# Service Update

## N242451390 First Responder Emergency Cut Loop Label Removal

**Release Date:** August 2024

Subject: N242451390 - Service Update  
First Responder Emergency Cut Loop Label Removal

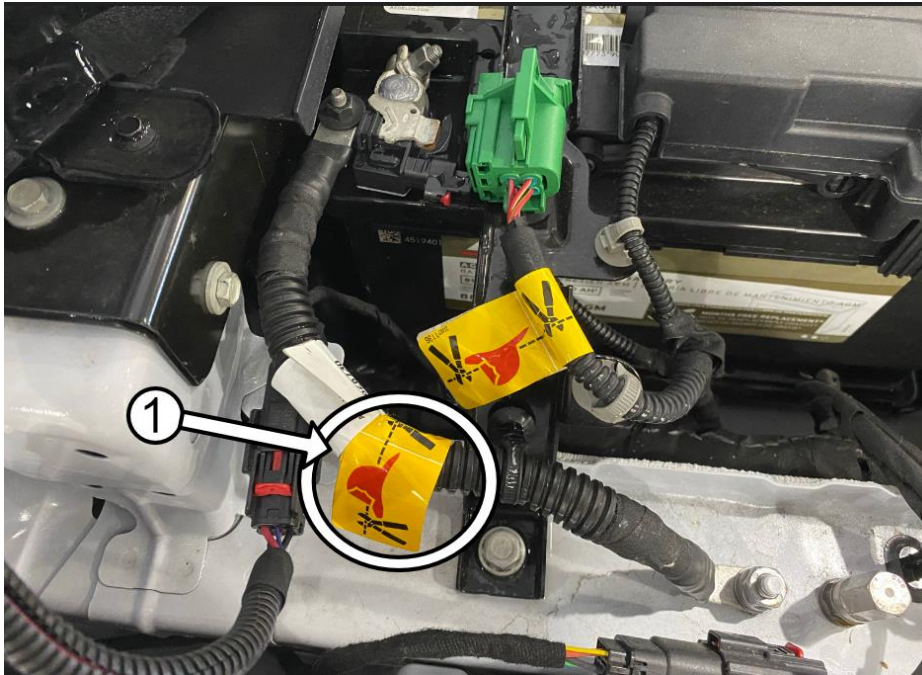
<b>Condition</b>	On certain vehicles listed above, the 12V battery negative cable was erroneously labeled with a First Responder Emergency Cut Loop label.
<b>Correction</b>	Dealers are to remove the First Responder Emergency Cut Loop label from the 12V battery negative cable.

**Important:** DO NOT remove the High Voltage Service Lockout Emergency Cut Loop Label.

**Caution:** Use caution to avoid damaging the 12V Battery Negative cable conduit.

2. Using a sharp cutting tool, remove the First Responder Emergency Cut Loop label (1) from the 12V Battery Negative Cable.
